DESIGN REVIEW COMMITTEE

August 19, 2026 6:00 PM

4.I. 3042 Lake Avenue Addition

DATE: August 13, 2026
TO: Tonya Hutson
FROM: Lynn Patterson
RE: **Design Review – 3042 Lake Avenue – Addition August 19, 2026**

1 PARTIAL SOUTH ELEVATION
A104 SCALE: 1/4"=1'-0"

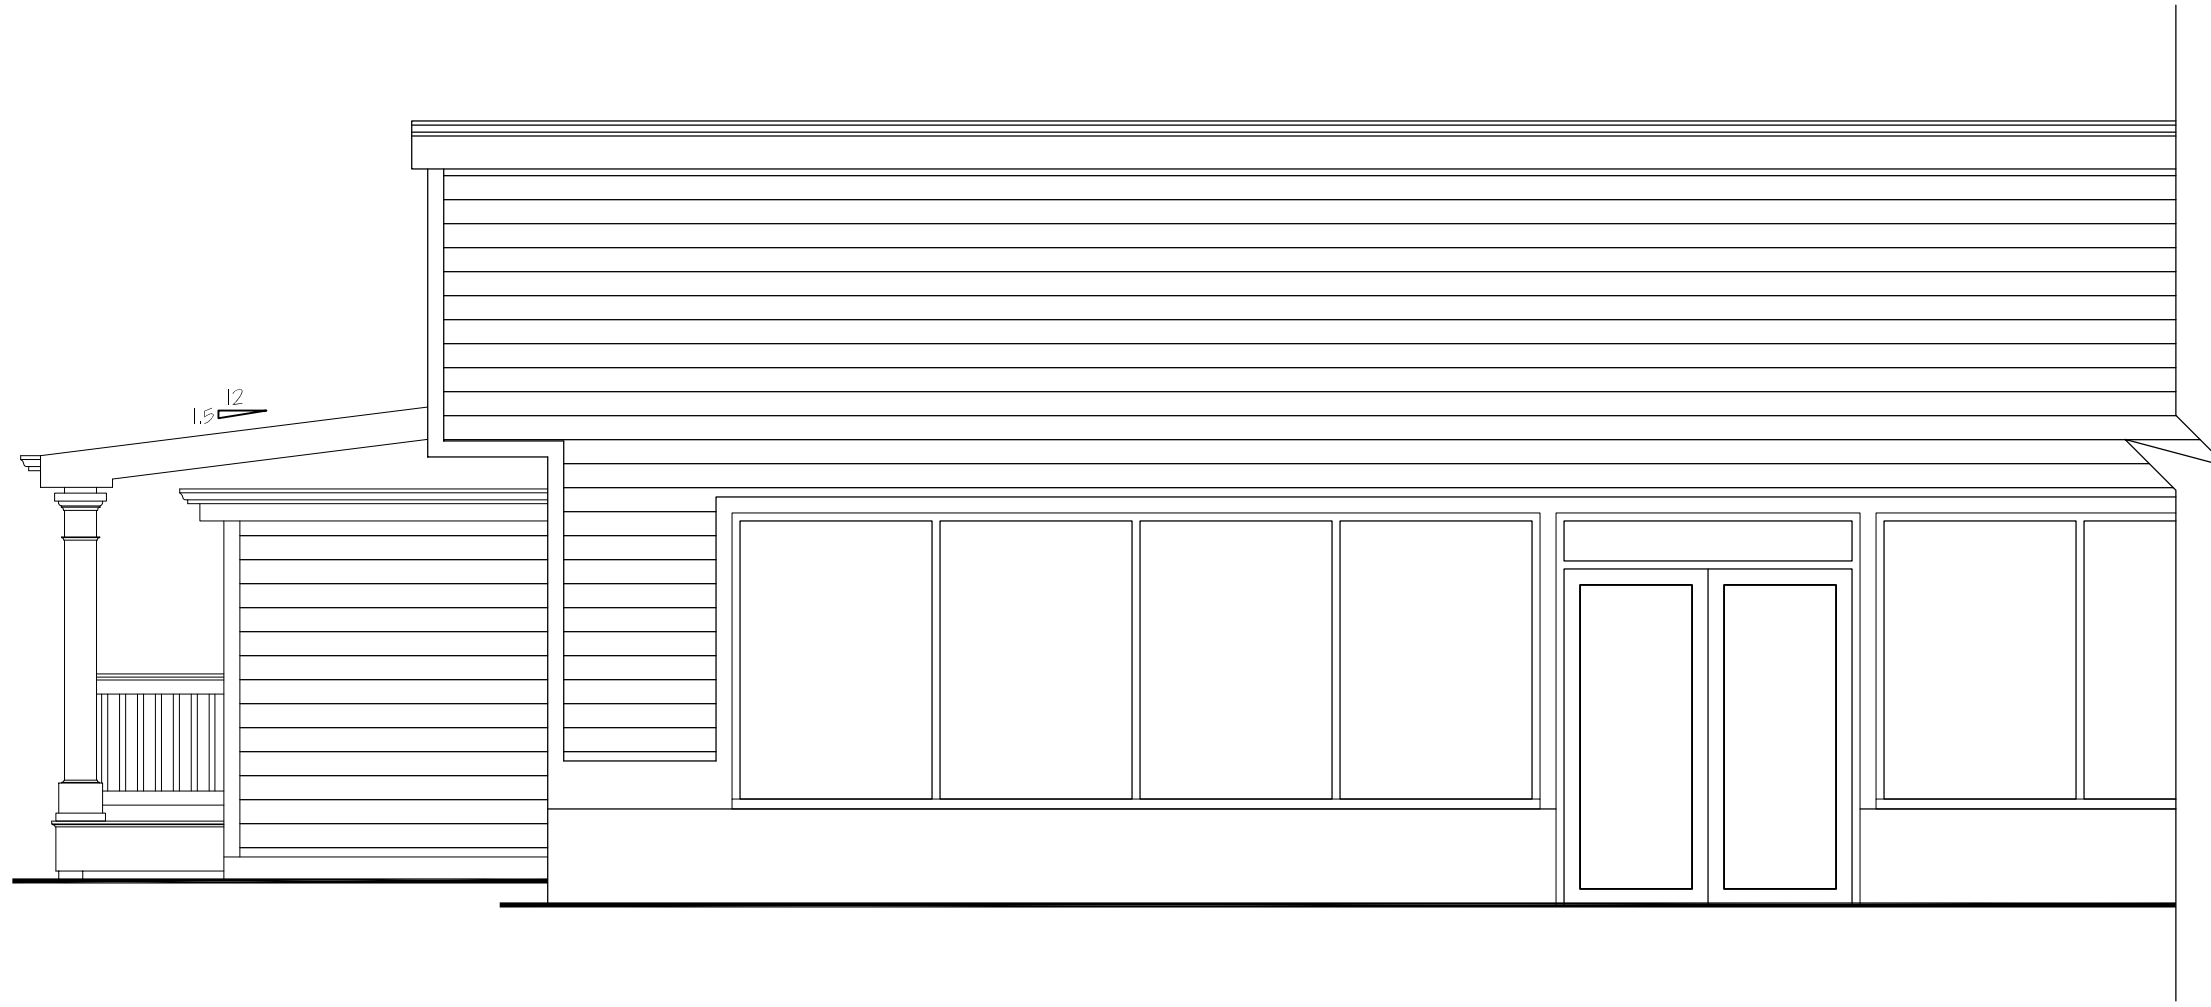
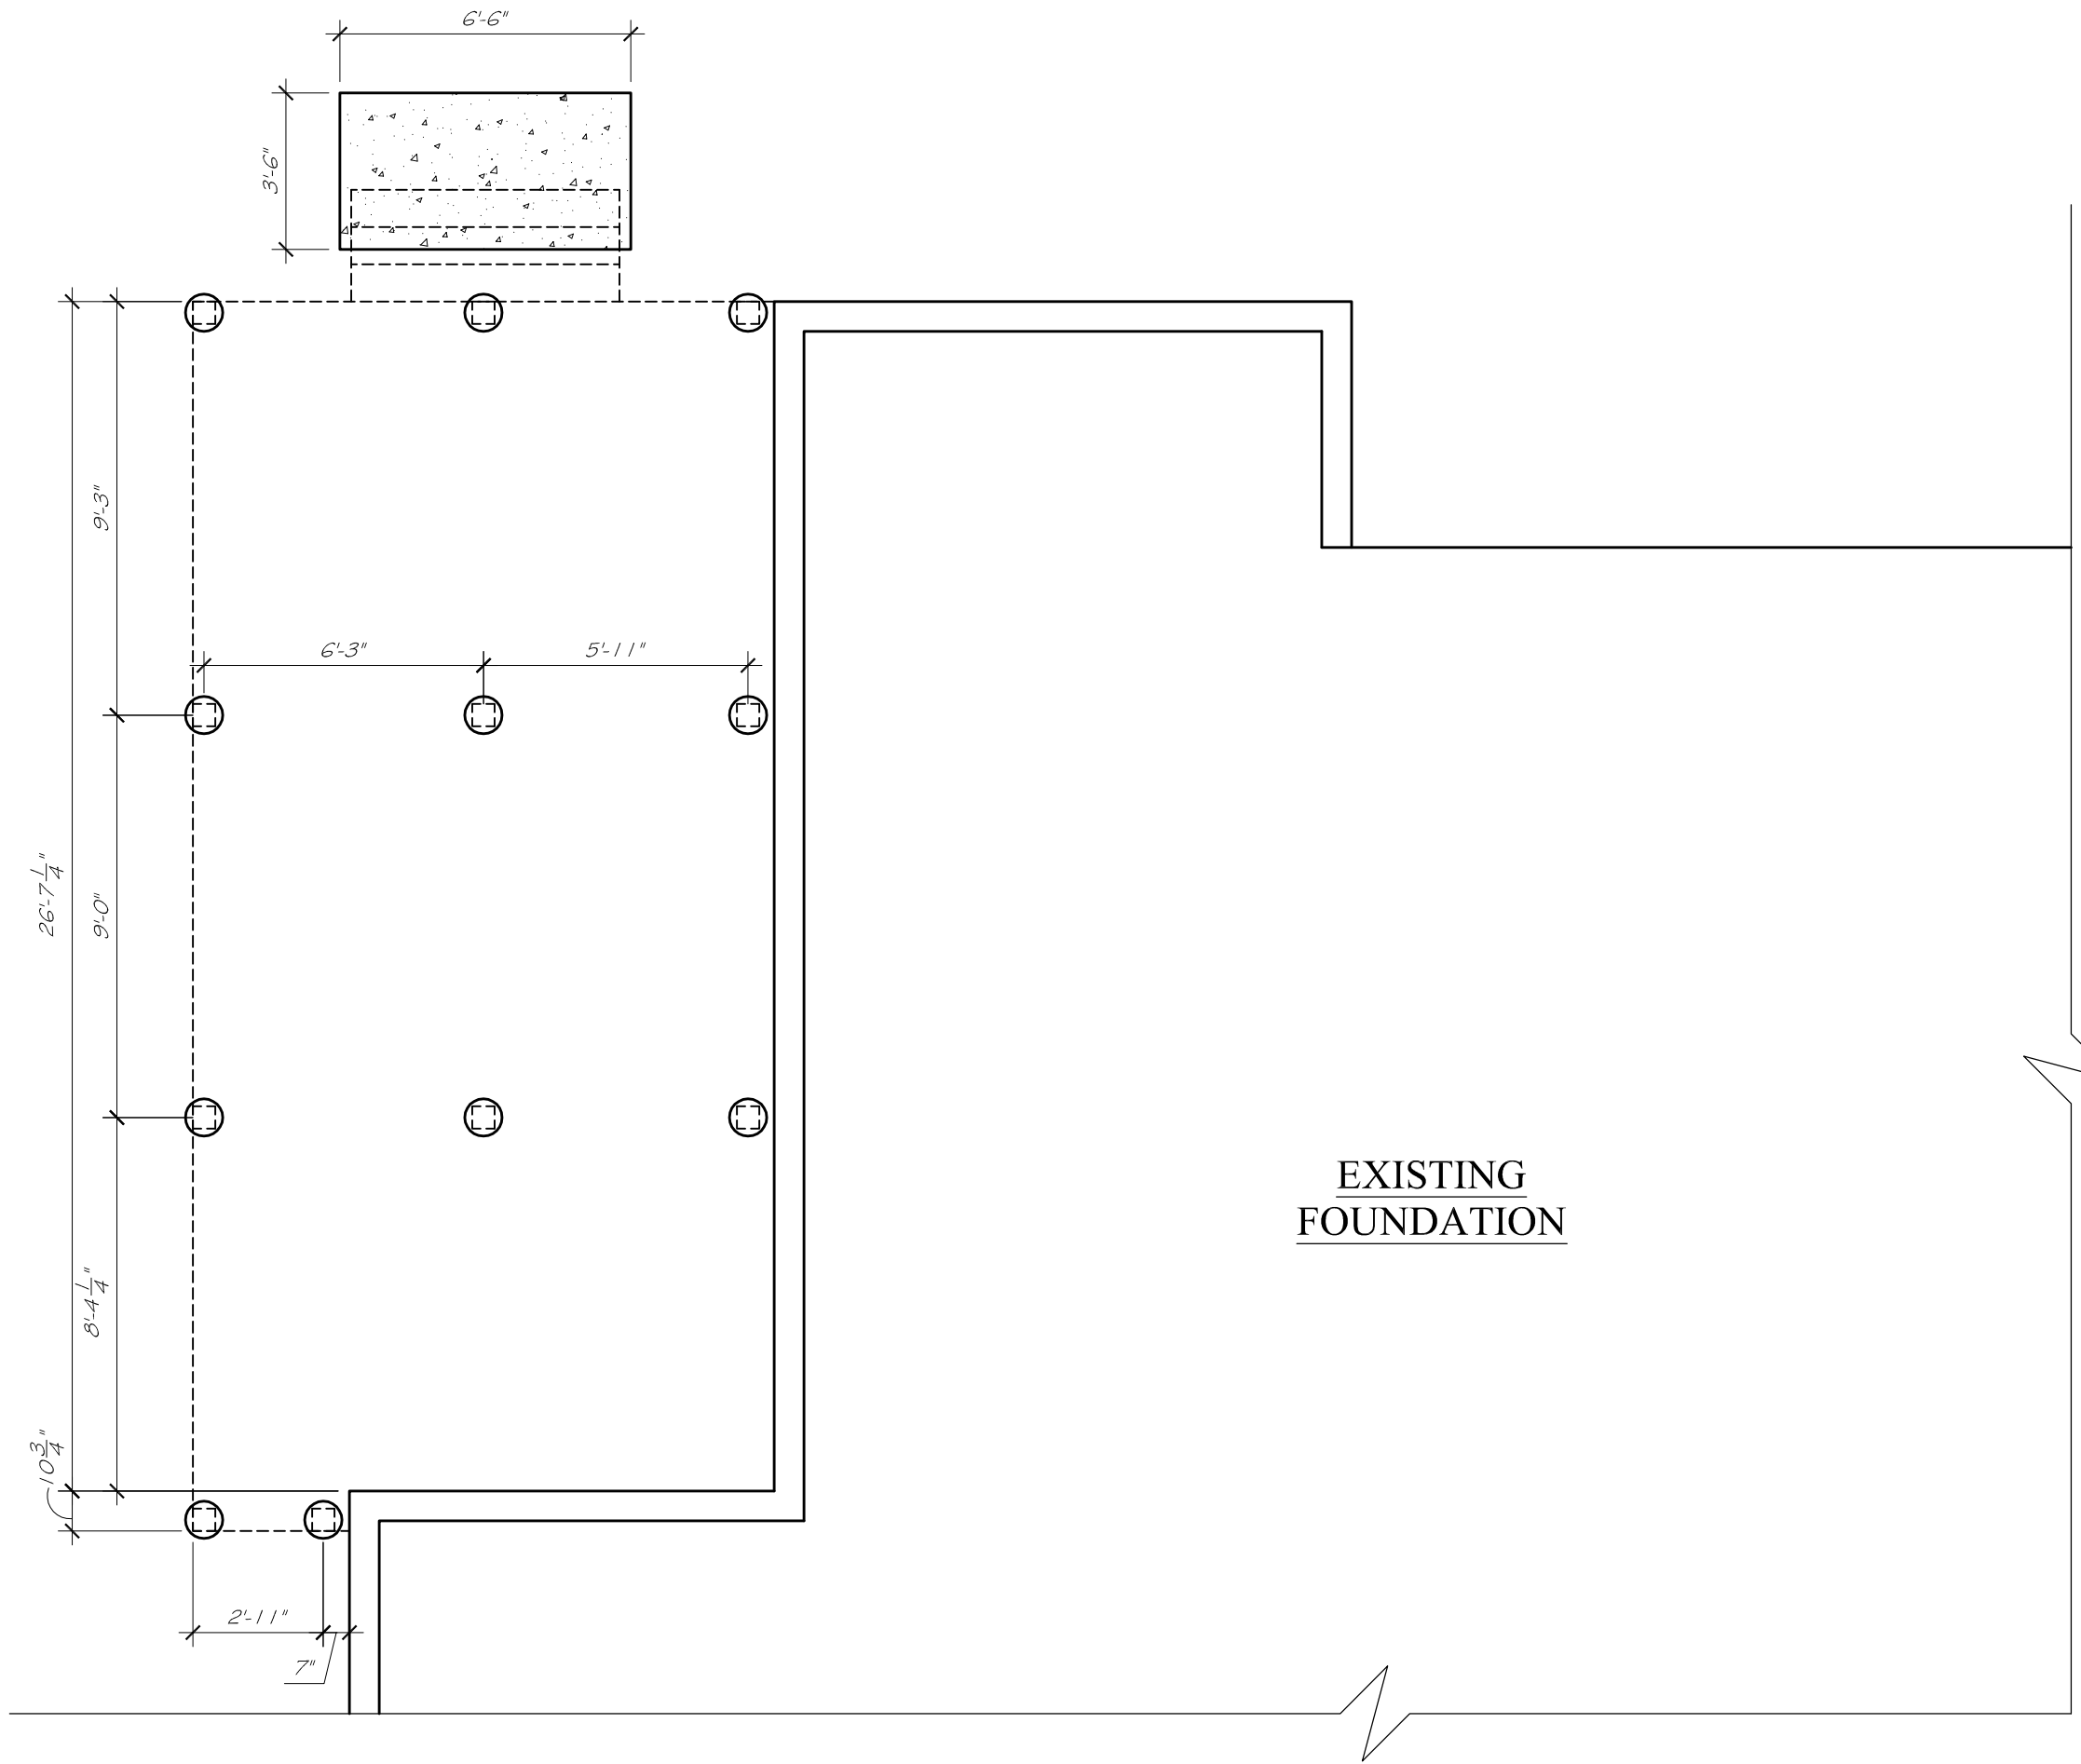
NOTES: Metal roof is proposed. Gutters appear on elevations but not on drawings. Please provide detail.

The applicant should show how the proposed patio encroaches on the driveway. The applicant should provide gutter and downspout detail.
